**Freightliner
Service Bulletin**

Description of Revisions: *This bulletin replaces the version dated July 2016. Two rows have been added to the Warranty table to cover two- and three-torque-rod procedures.*

Replacing or Upgrading AirLiner 40k Transverse Torque Rods

Fig. 1, Airliner 40,000 lbs Rear Suspension

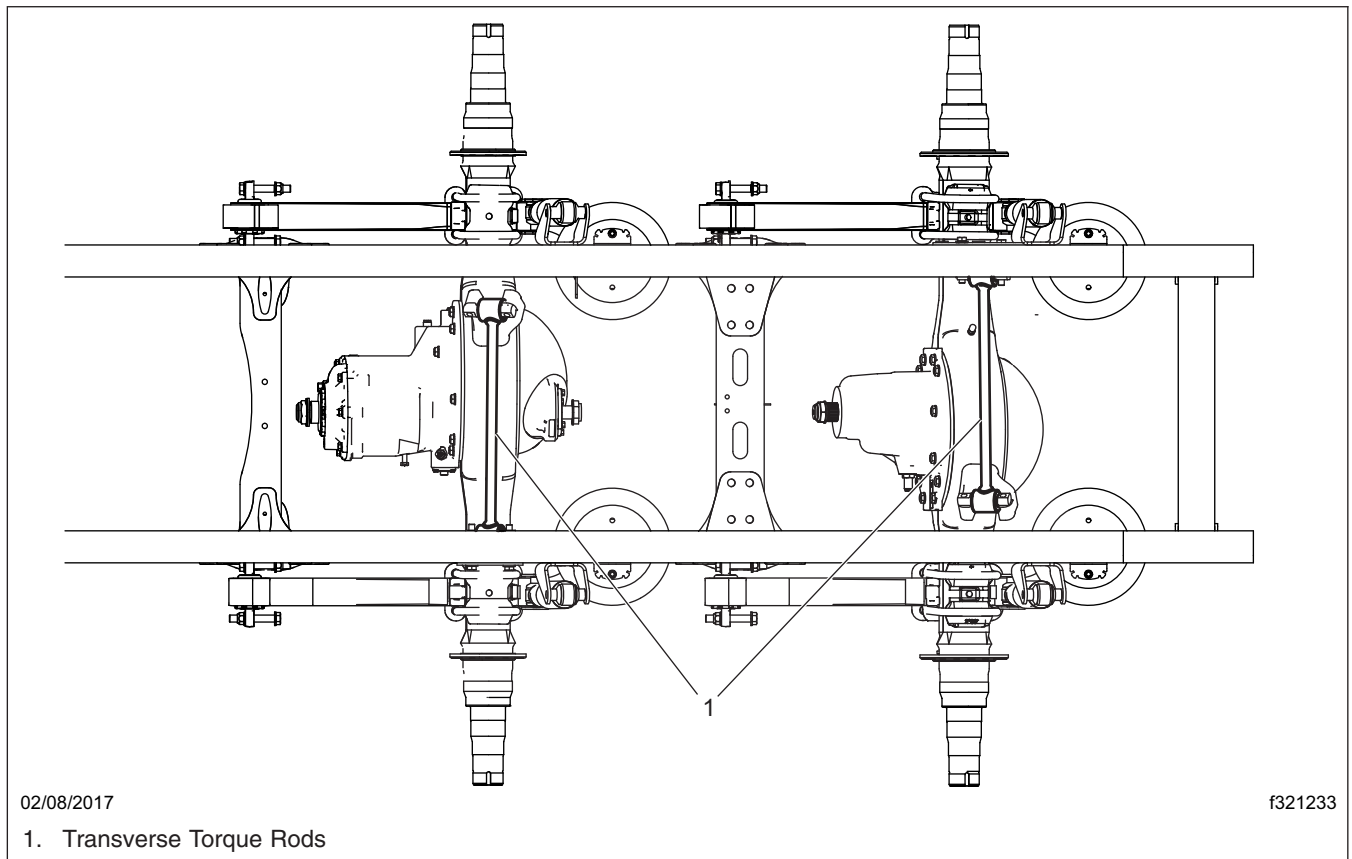
The standard-duty transverse torque rod 16-16749-002 (see **Fig. 1**), used in the Airliner 40,000 lbs rear suspension application can fail due to the bar pin bushings walking out, causing metal to metal contact between the torque rod and axle tower bracket. When replacing a failed Airliner 40,000 lbs transverse torque rod, always use the Airliner suspension 46,000 lbs transverse torque rod 16-18972-000 as the replacement rod, which has curled ends to better contain the bushing and prevent bushing walk-out.

Airliner Rear Suspension 46k Transverse Torque Rod		
Part Number	Description	Quantity
16-18972-000	Control Rod, Lateral, HD, A-L (Heavy Duty, 46k)	1
